ADDENDUM NO. 002

RE: Water System Capital Improvements – Phase II
For Town of Bluefield
T&L Project No. 16176

DATE: June 8, 2023

SERVICE DISCONNECT SWITCH - 3-POLE, SOLID NEUTRAL, 600A, 240/120V, FUSED AS INDICATED, HEAVY DUTY, NEMA-3R ENCLOSURE, UL LISTED FOR SERVICE ENTRANCE, EQUAL TO SQUARE D CLASS 366. ENCLOSED BREAKER OF SIMILAR RATINGS MAY ALSO BE USED.

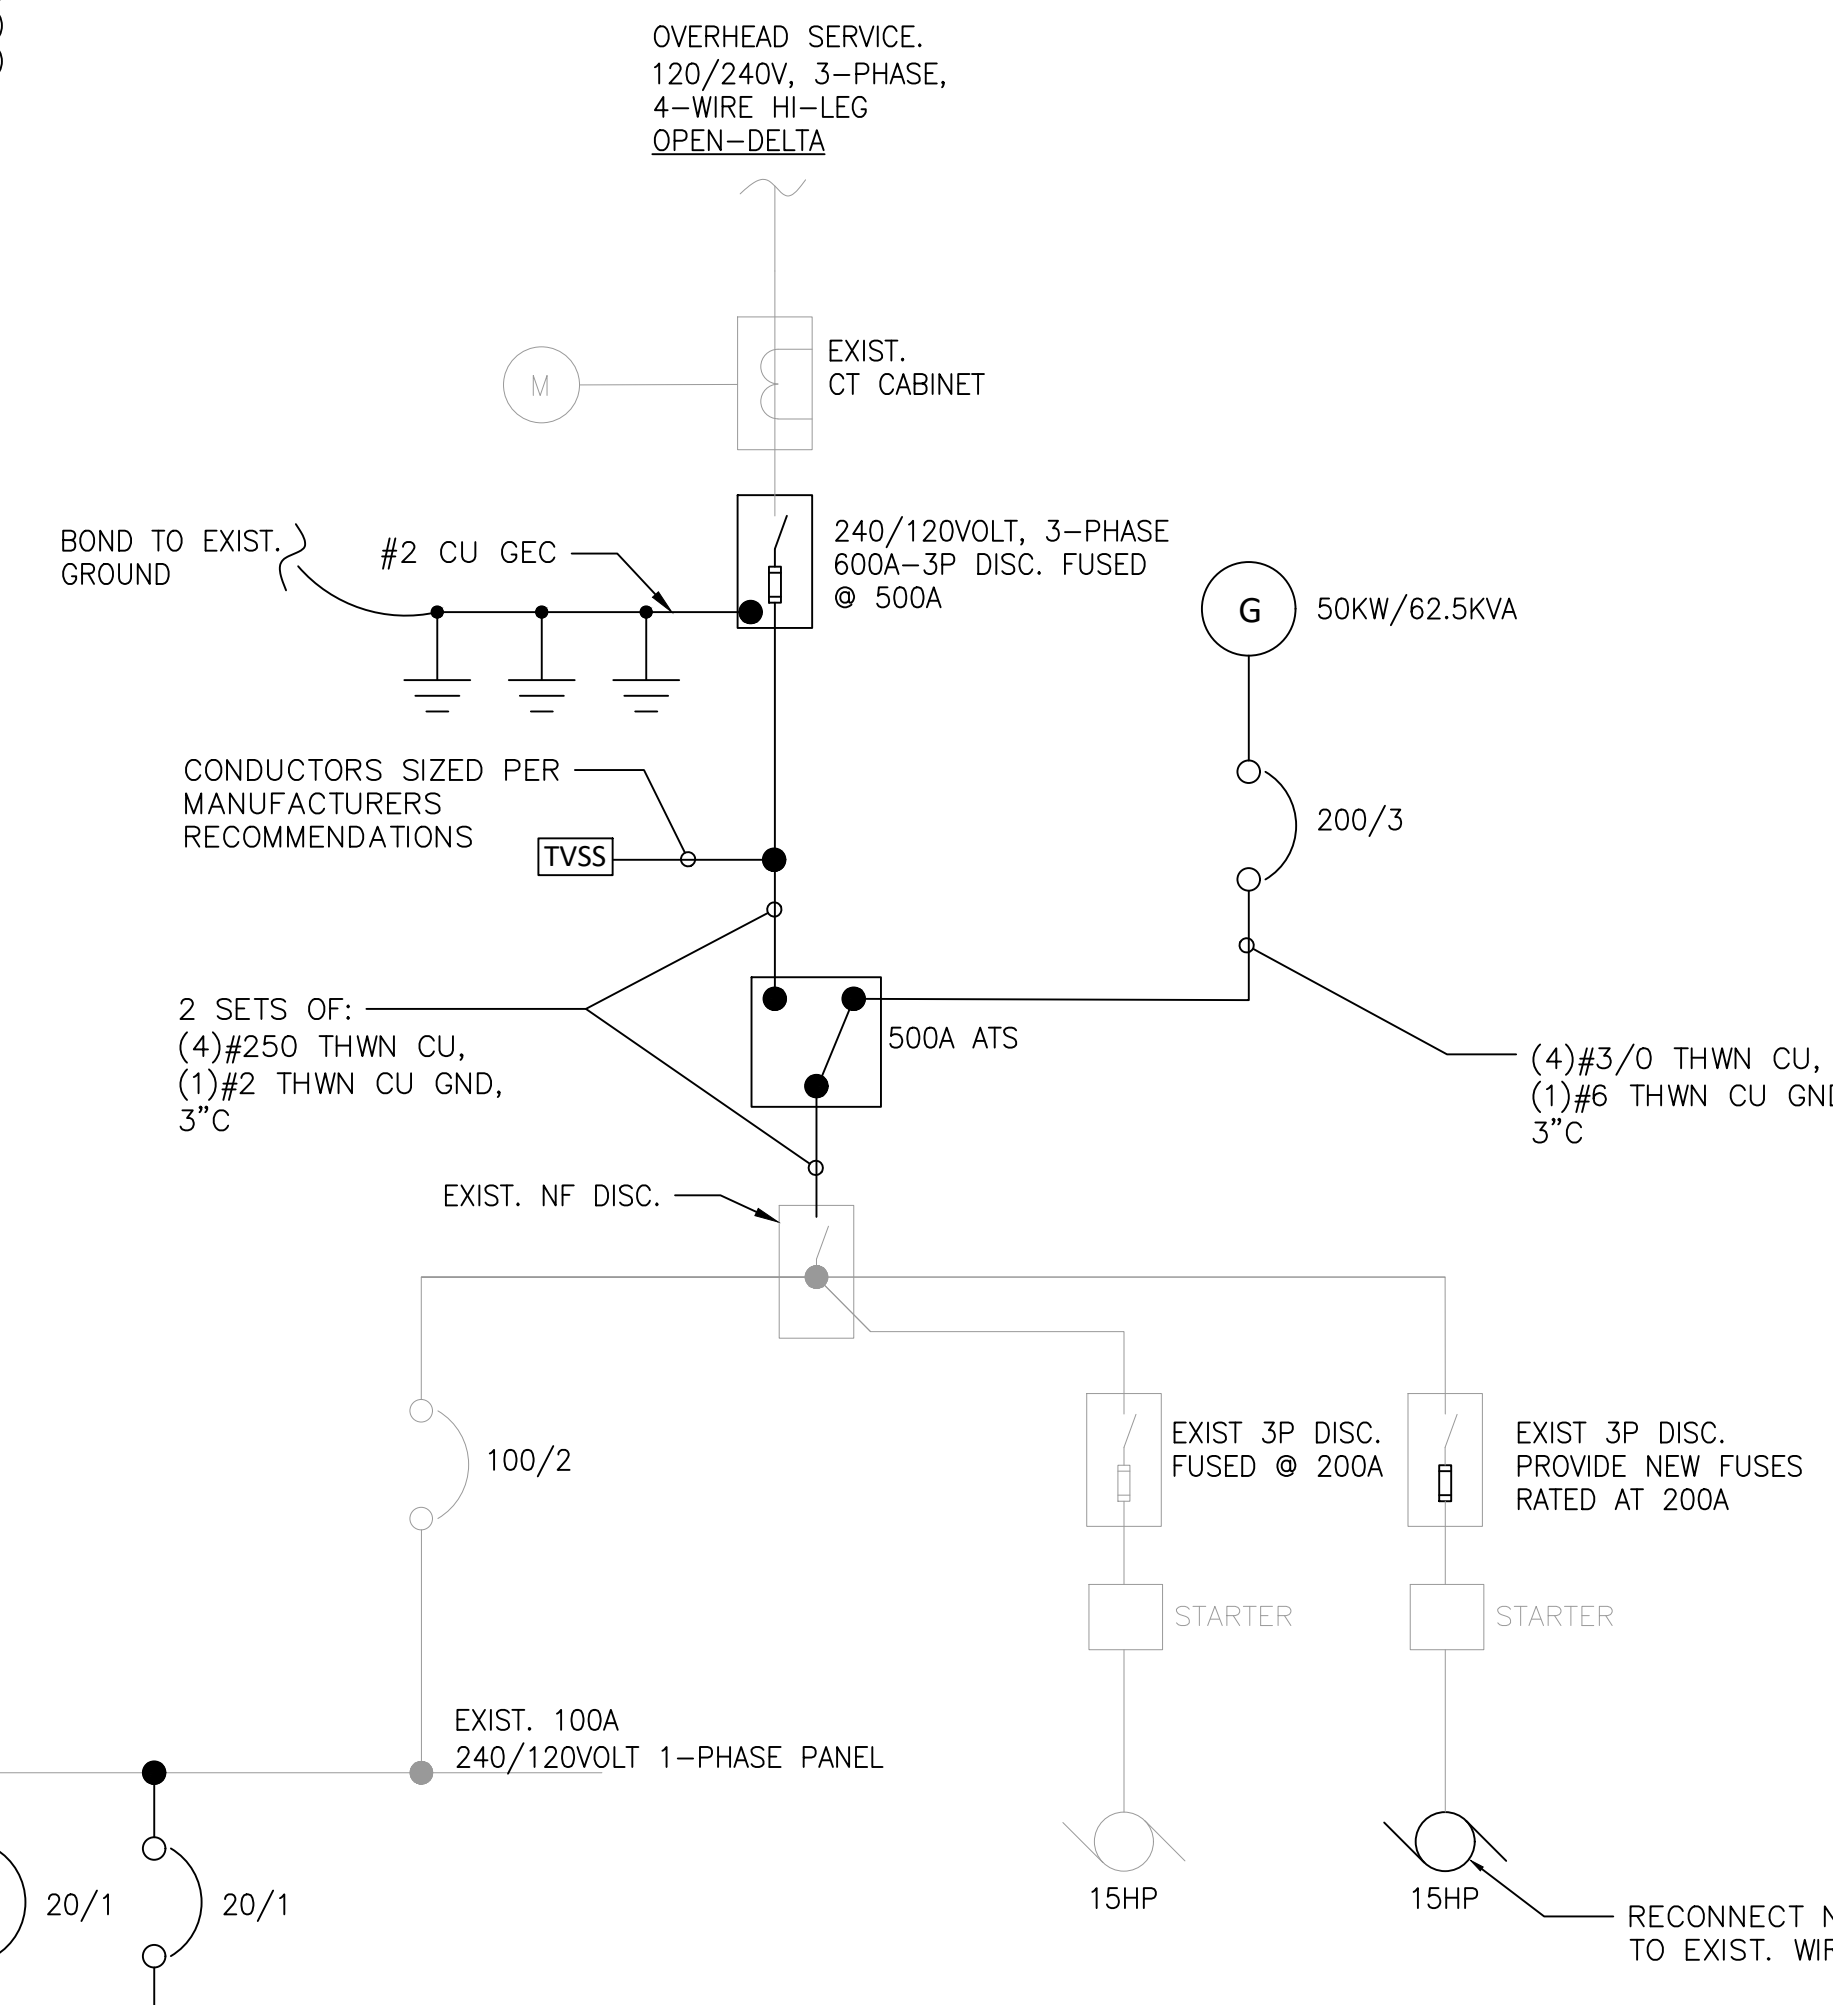
1. All new camera systems shall be on separate networks from the main station controls.
2. The 0.8PF stated on Risers E102 and E103 applies to both single or three-phase power.
3. The remote is to provide access on the exterior of the generator enclosure such that fuel is not spilled inside of the generator enclosure. Fuel fill shall be lockable.
4. Pipe material for lines between the basin and outfall shall be ductile iron as specified in Specification Section 33 1116 – Water Utility Distribution and Treatment Piping and Valves.

1. Drawing C103 has been revised to add new 12' wide double swing gates to the existing fencing between the park and the water treatment plan and add hatching to delineate the area adjacent to the basins where additional earthwork shall be performed to satisfy flood mitigation requirements. The revised drawing is enclosed.
2. Drawing C201 has been revised to add clarification for the ornamental aluminum fencing. The revised drawing is enclosed.
3. Drawing C207 has been revised to clarify the motor requirements for the Raw Water Pump. The revised drawing is enclosed.
4. Drawing E101 has been revised to shift text for visibility. The revised drawing is enclosed.
5. Drawings E102 and E103:
 - a. Additional information has been provided in regards to startup requirements.
 - b. Each ATS withstand requirement value based off of given fault current has been corrected.

- EXISTING GROUND ELECTRODE CONDUCTOR MAY BE REUSED IF CONDUCTOR CAN BE TRANSFERRED WITHOUT SPLICING AND IS SIZED AS INDICATED.
 - THE MAXIMUM AVAILABLE FAULT CURRENT FOR THE BRIERWOOD PUMP STATION IS 921A. ALL INSTALLED EQUIPMENT MUST MEET OR EXCEED THIS RATING. PROVIDE LABEL FOR NEW SERVICE DISCONNECT IN ACCORDANCE WITH THE NEC 110.24 'AVAILABLE FAULT CURRENT 921AMPS, 02/21/2023.'

- THE MAXIMUM AVAILABLE FAULT CURRENT FOR KERSEY PUMP STATION IS 1766A. ALL INSTALLED EQUIPMENT MUST MEET OR EXCEED THIS RATING. PROVIDE LABEL FOR NEW SERVICE DISCONNECT IN ACCORDANCE WITH THE NEC 110.24 'AVAILABLE FAULT CURRENT 1766AMPS, 02/21/2023.'
